# MORRO BAY – CAYUCOS WASTEWATER TREATMENT PLANT UPGRADE

Final Environmental Impact Report  
SCH No. 2008101138

Prepared for  
City of Morro Bay and  
Cayucos Sanitary District

December 2010

**Figure 3.7-2**  
FEMA Flood Zones

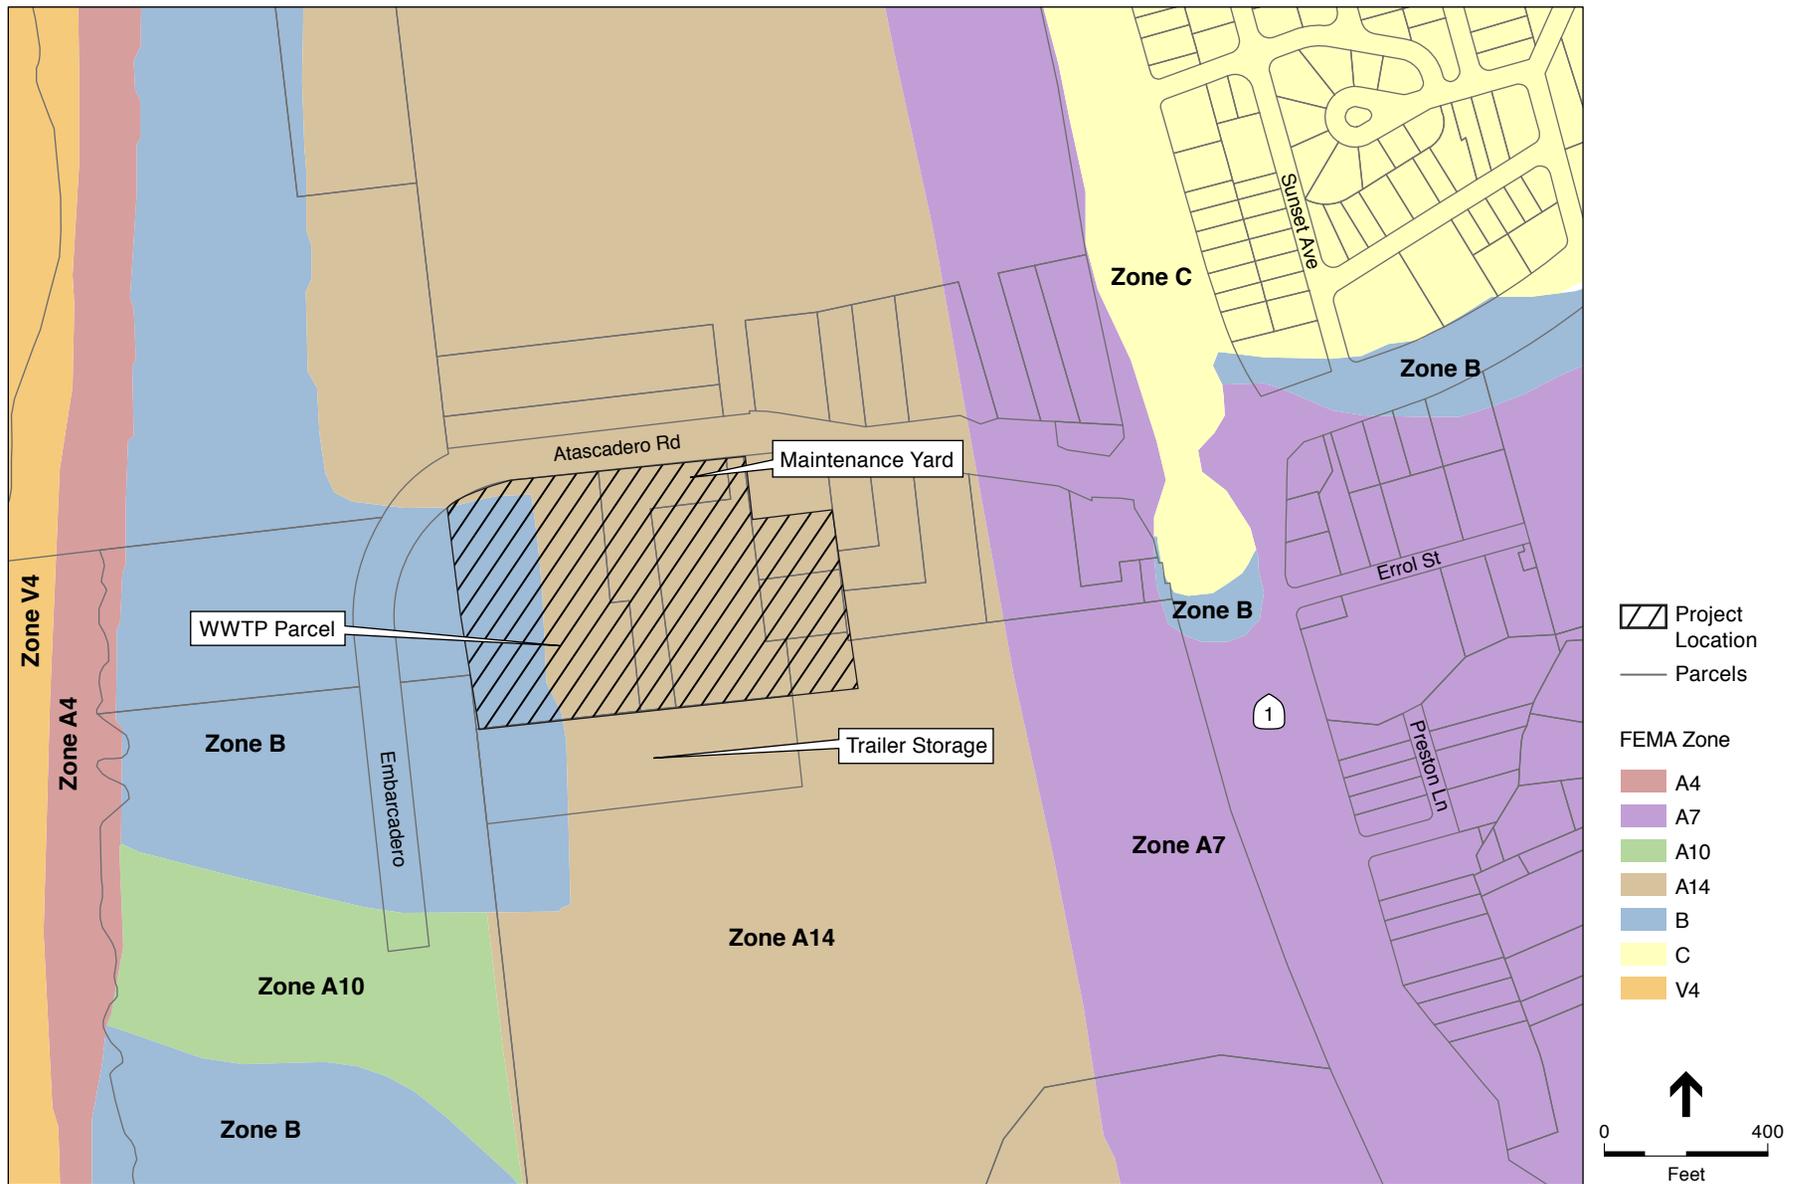
Figure 3.7-2, which characterizes the FEMA flood zones, does not provide a description of what the FEMA zone designations mean in terms of flooding hazard.

The comment states Figure 3.7-2, which characterizes the FEMA flood zones, does not provide a description of what the FEMA zone designations mean in terms of flooding hazard.

The comment states there is no explanatory key in the FEMA Flood Zone figure (Figure 3.7-2 of the Draft EIR). The comment asks what the meanings are behind the project site's designated A-14 and B FEMA Flood Zones.

Figure 3.7-2 in the Draft EIR has been revised to include a description of the FEMA flooding hazard designations that are characterized in the figure. The revised Figure 3.7-2 is included in Chapter 11 of this Final EIR.

The Draft EIR Figure 3.7-2 has been revised to include a key that clarifies the FEMA flood hazard zones. See attached Figure 3.7-2 at the end of this chapter.
